UNITED STATES PATENT AND TRADEMARK OFFICE

Office Action Summary	Application No. 10/525,864	Applicant(s) HANLON, MARK	
	Examiner EVAN H. LANGDON	Art Unit 3654

DETAILED ACTION

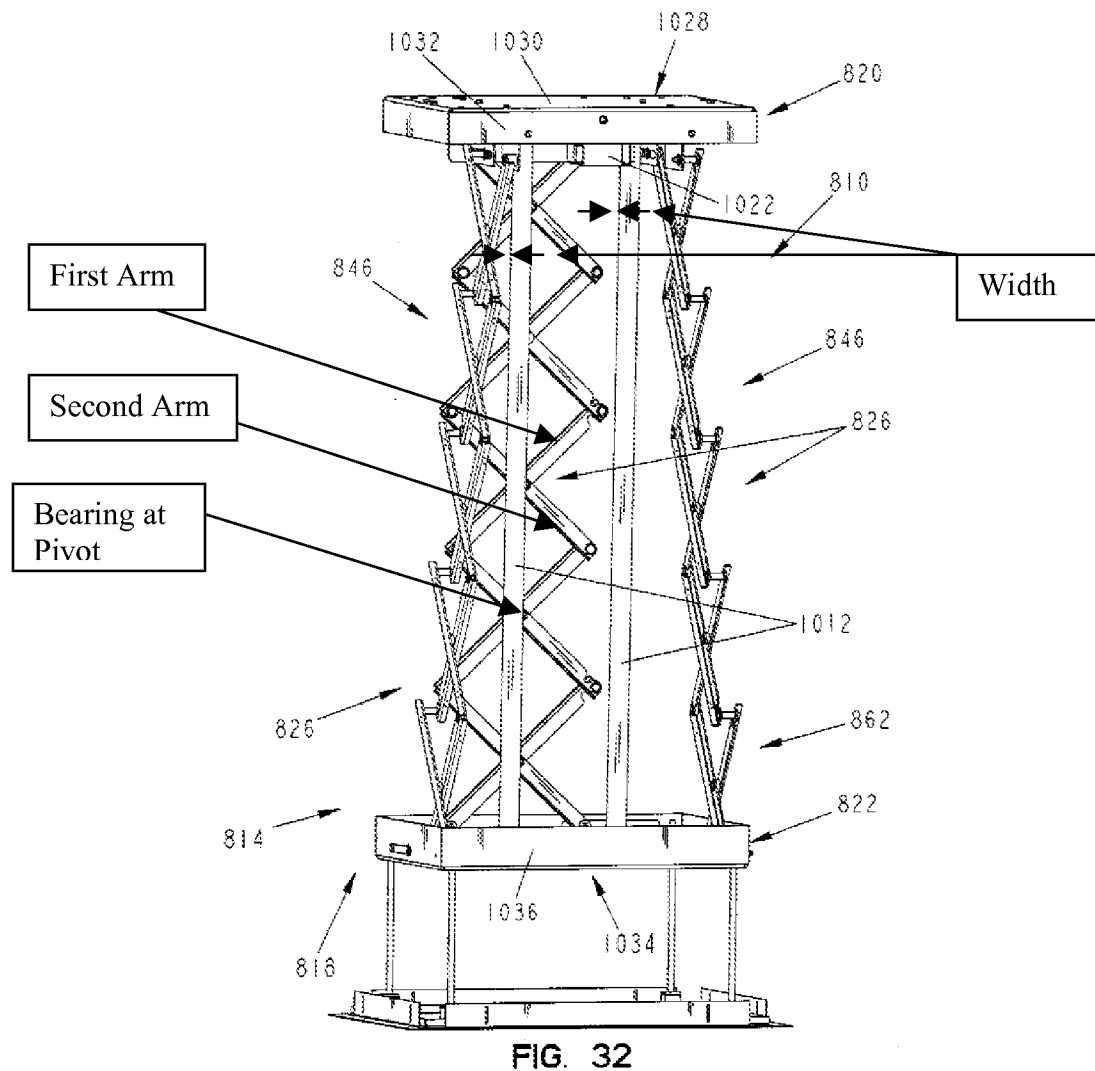
In regards to claims 1 and 17, Enchos discloses a ceiling mounted lift, comprising:

a support frame 1028 housing a double fabric panel drive assembly 824 (Fig. 31) having a first panel 1012 having a width (see below) that defines a first plane, and a second panel 1012 that defines a second plane that is not co-planar with the first plane the panels operating to raise and lower a lifting platen 1034; and

a stabilizer 826 having a first arm and a second arm (Fig. 32 and 36, see below), such stabilizer disposed between the support frame 1028 and the lifting platen 1034, and disposed relative to the panels to prohibit motion in all but one plane.

In regards to claims 2, Enchos discloses the stabilizer comprises a bearing at a pivot (see above, Fig. 39) joining the first and second arms.
